BEST 40H Spindle & Lever Product Update

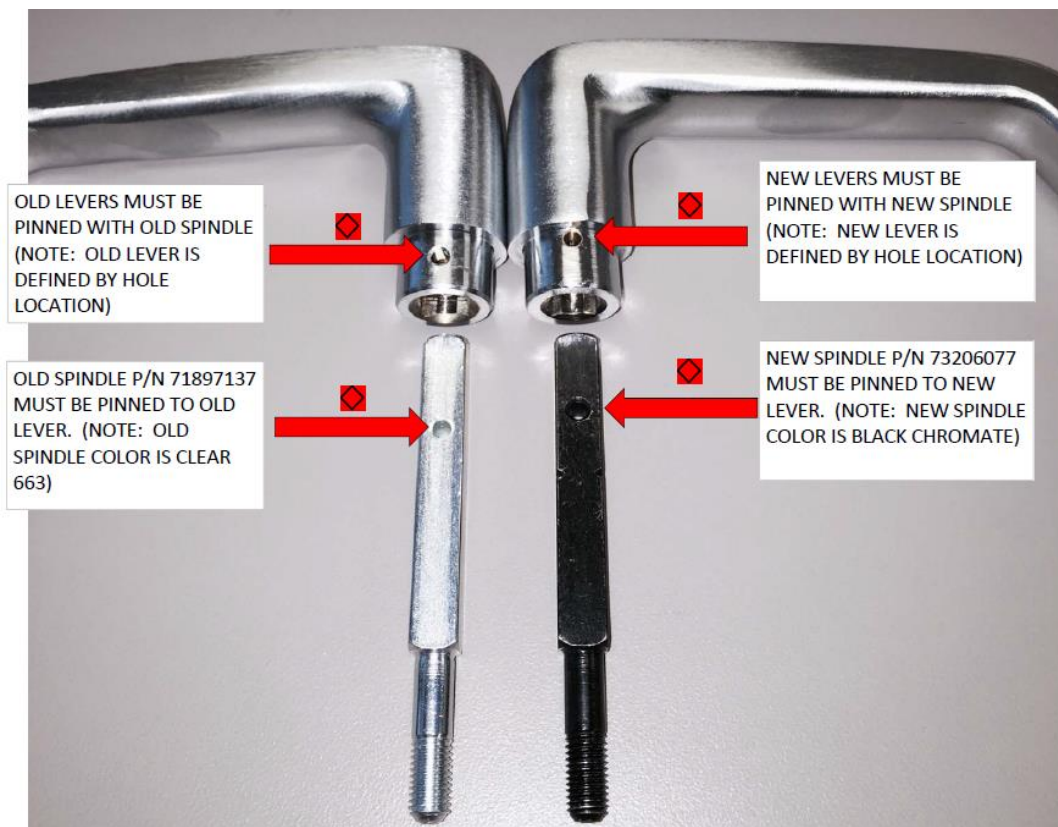
The STANLEY Security Products Engineering team is releasing an updated spindle and lever for the BEST 40H series mortise locks. As part of the ongoing product improvements process, additional updates were made to the BEST 40H spindle and lever to enhance the attack resistance of the lock. The spindle is now made of a higher strength alloy material and the positioning of the lever pinning holes has changed.

Next Steps: This will be a rolling change with the new spindles & levers to begin shipping the end of December 2014. With this being an ongoing process, it will be important for customers to use the picture and descriptions below to identify exactly what they need to replace. The old spindles and levers are not compatible with the newly enhanced spindle and lever. Please see below for the new spindle and lever part numbers as well as a description of the differences between the two.
